**PLANNED UNIT DEVELOPMENT  
& SUBDIVISION STAFF REPORT****Date: April 1, 2010****DEVELOPMENT NAME**

Congress Street Subdivision, Resubdivision of

254 Congress Street  
(North side of Congress Street, 60'+ West of North Joachim Street, extending to the West side of North Joachim Street, 78'+ North of Congress Street).

Planned Unit Development Approval to amend a previously approved Planned Unit Development to allow shared access and parking between multiple building sites, and Subdivision approval to create 4 lots.

# SITE PLAN

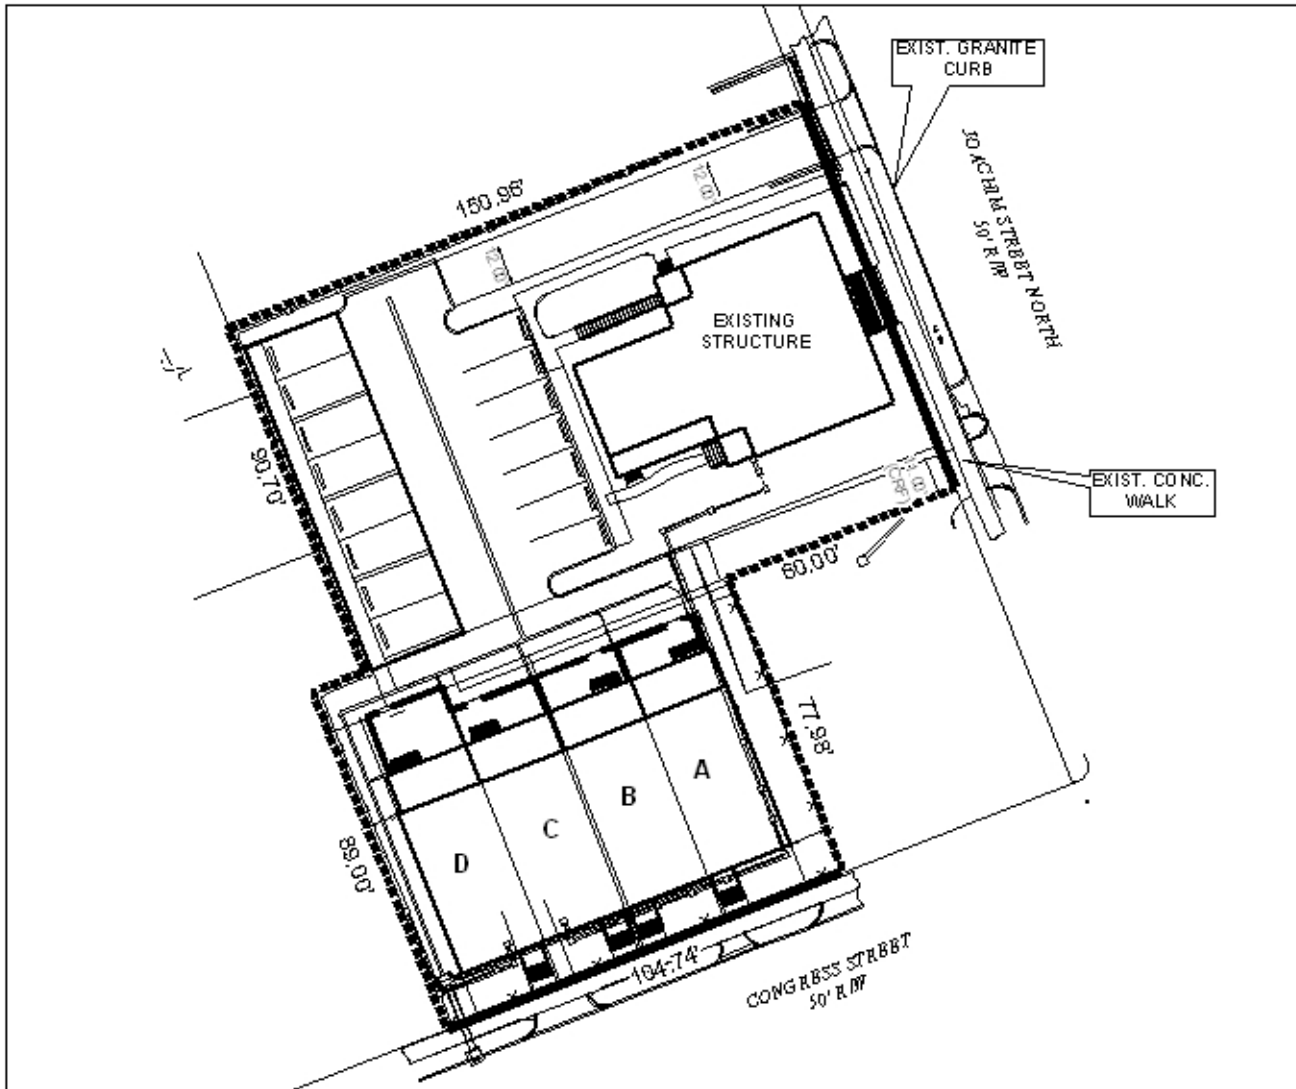
The proposed parking area will be accessed via a one-way entrance from North Joachim Street, and will exit via a separate one-way entrance onto North Joachim Street. It appears that the entry drive will be approximately 12-feet wide; however, it appears that the exit drive will fall below this dimension.

Dumpster locations for the site are not depicted on the site plan to comply with Section 64-4.D.9 of the Zoning Ordinance; therefore, the applicant should make a provision for dumpster locations and place a note on the site plan stating that dumpsters will be completely screened from view. If dumpsters will not be used, provide a statement indicating such, and how garbage will be removed from the site.

- 5) closure and landscaping of all unused curb-cuts, as shown on the site plan;
- 6) depiction of the 5-foot minimum building setback line on the PUD site plan;

- 4) depiction of dumpster locations on the site plan (if they will be utilized) to comply with Section 64-4.D.9 of the Zoning Ordinance and placement of a note on the site plans stating that dumpsters will be completely screened from view, or placement of a note stating how garbage will be removed;
